AT THE NORFOLK INTERNATIONAL AIRPORT

ADDENDUM NO. 1

RFQ-FY25-100-3

Request for Qualifications and Proposals for Construction Manager at Risk (CMR) for Norfolk International Airport (ORF) Consolidated Rental Car Facility

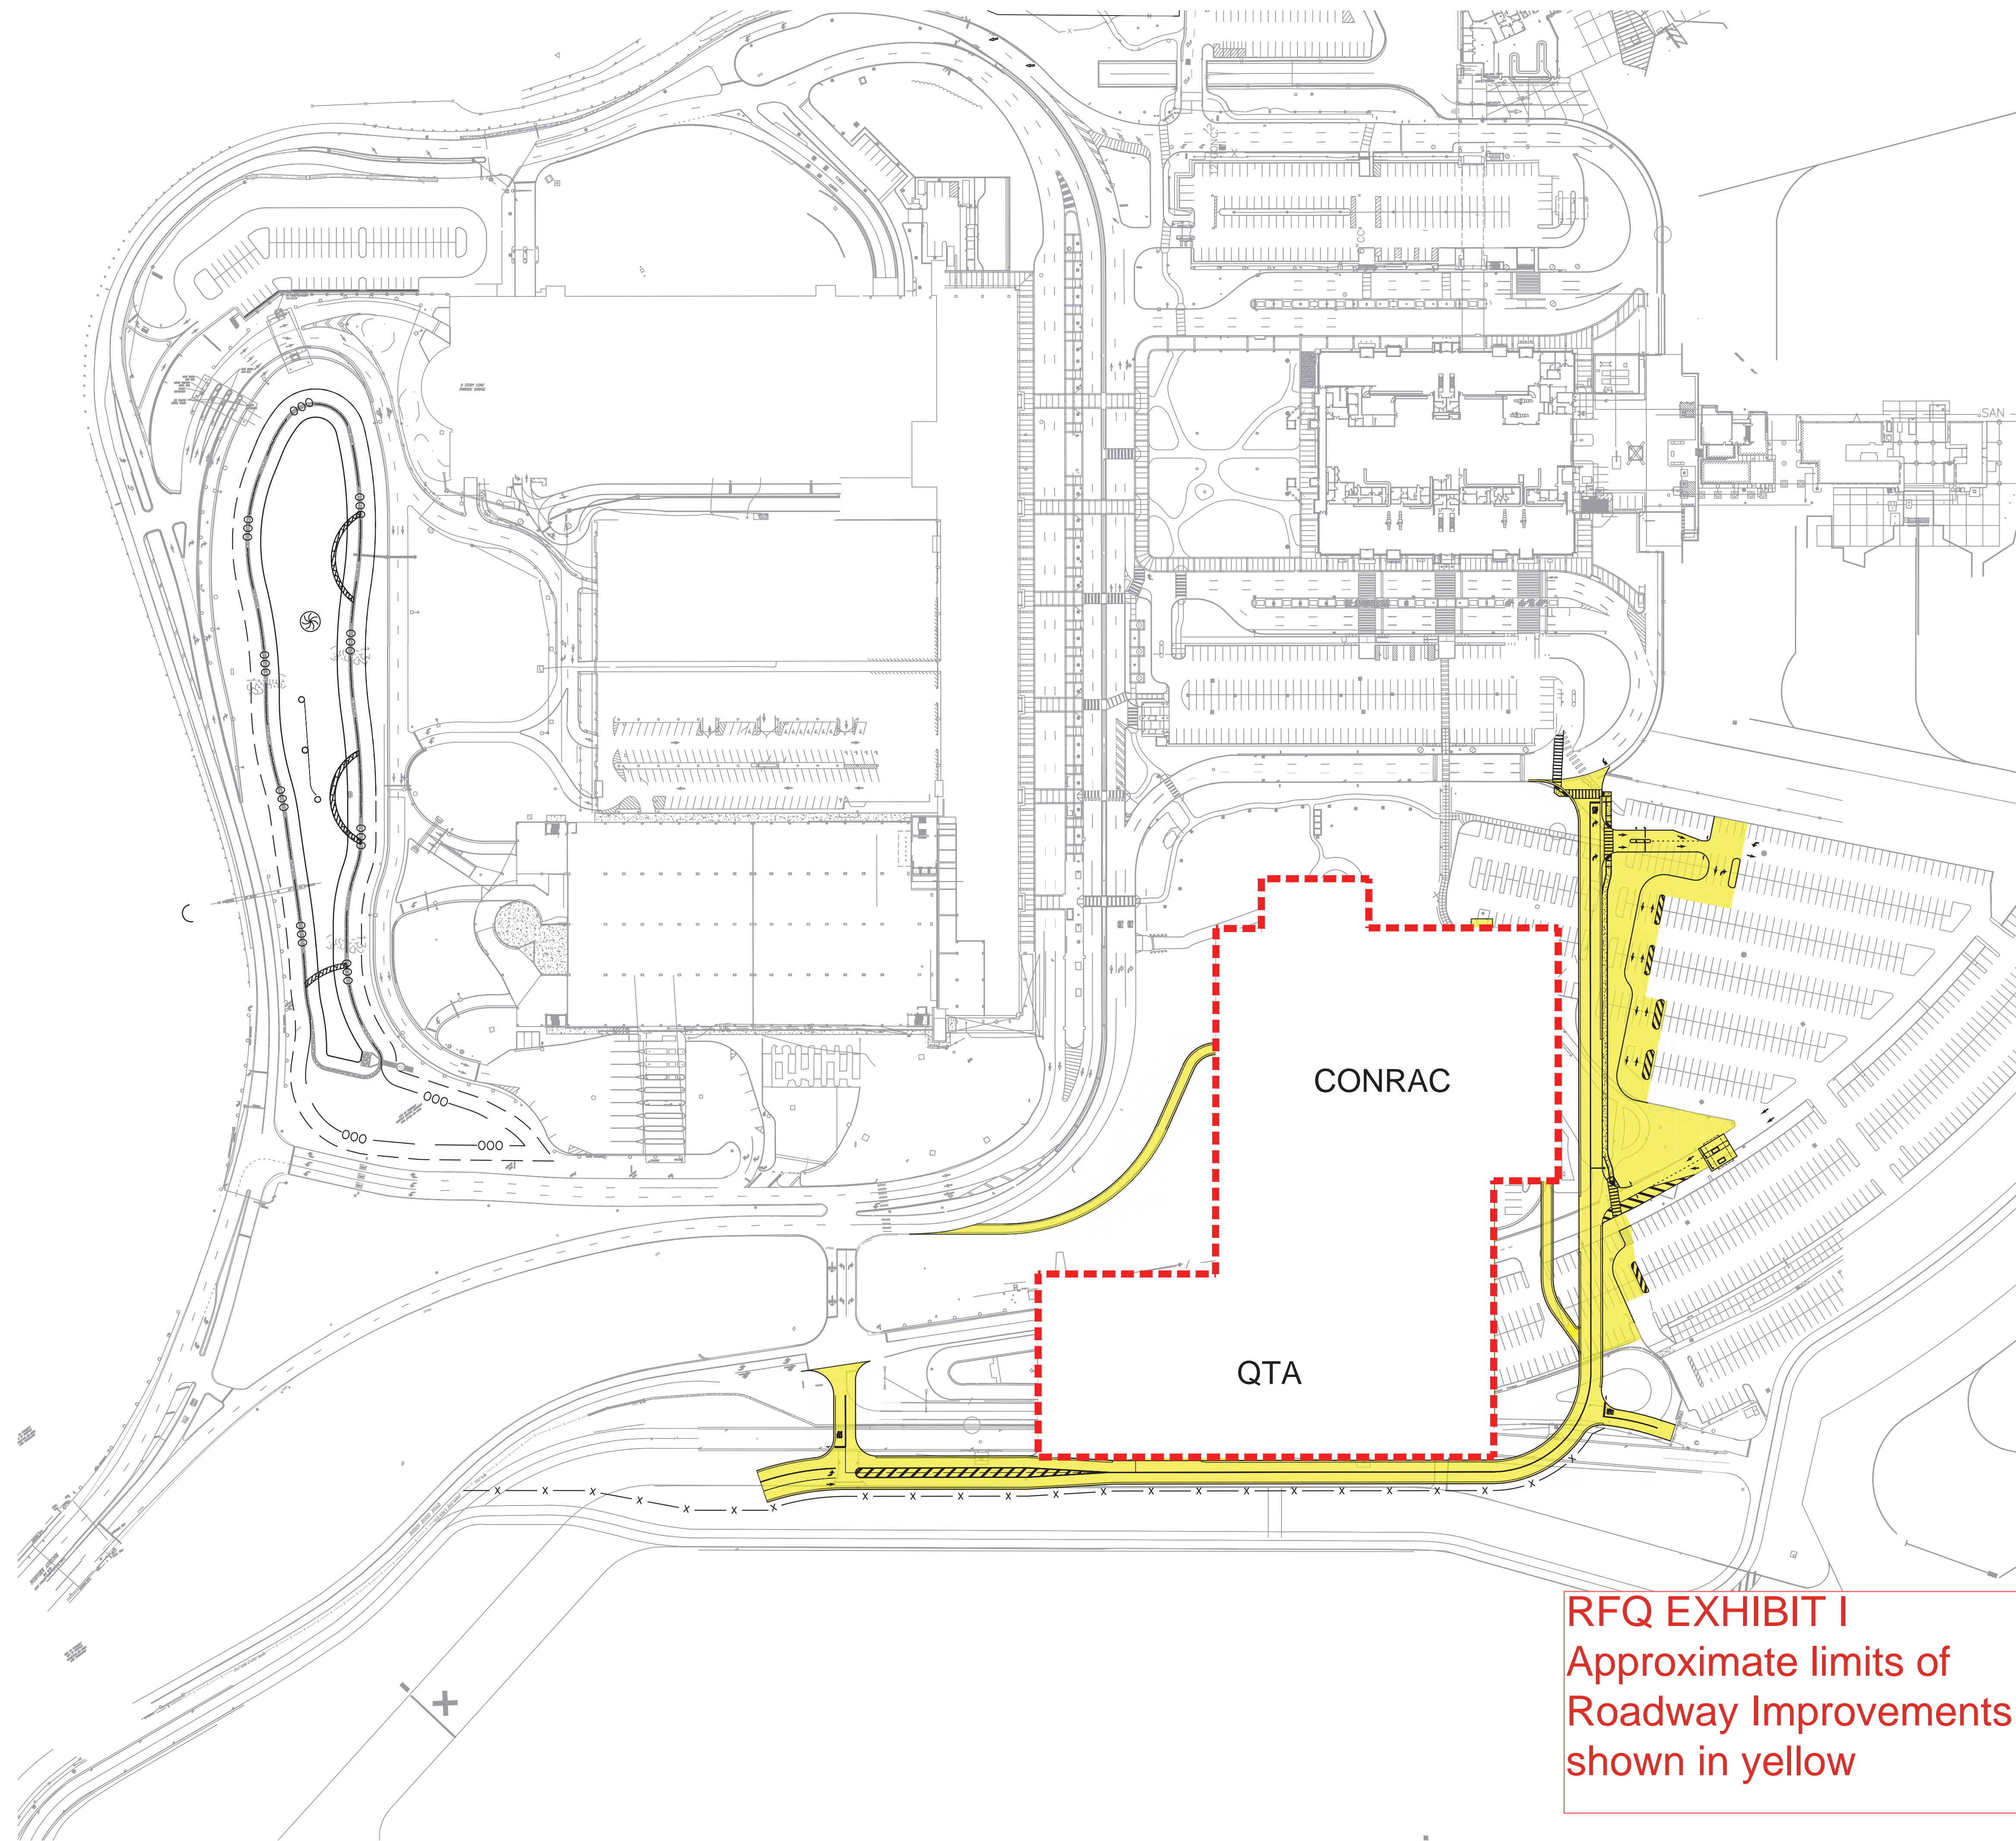
1. Remove and replace page 2 of RFQP with attached version
 - a. List of Included Exhibits updated to include Exhibit I and J
2. Remove and replace page 7 of RFQP with attached version
 - a. Project description revised to include the scope of work reflected in Exhibit I and J

The Project consists of constructing a new consolidated rental car facility (ConRAC) and all associated necessary ancillary work. The ConRAC is generally described as a 270,000 square foot parking structure consisting of three levels and a fourth level hard cap. Additionally, a Quick Turnaround facility used by the rental car companies to clean and fuel vehicles will be constructed adjunct to the parking structure. Refer to **Exhibit H** for ConRAC concept drawings available at the time of posting this RFQ/RFP. Project includes Roadway Work as shown in **Exhibit I** and the relocation of the TNC and Taxi Facilities as shown in **Exhibit J** as required to enable the ConRAC Facility. Project includes the realignment of Robin Hood Road as shown in **Exhibit J** to enable proper function of relocated TNC and Taxi facilities. Scope is subject to change however, Offerors should anticipate the final project scope to be similar to what is documented in Exhibits H, I and J.
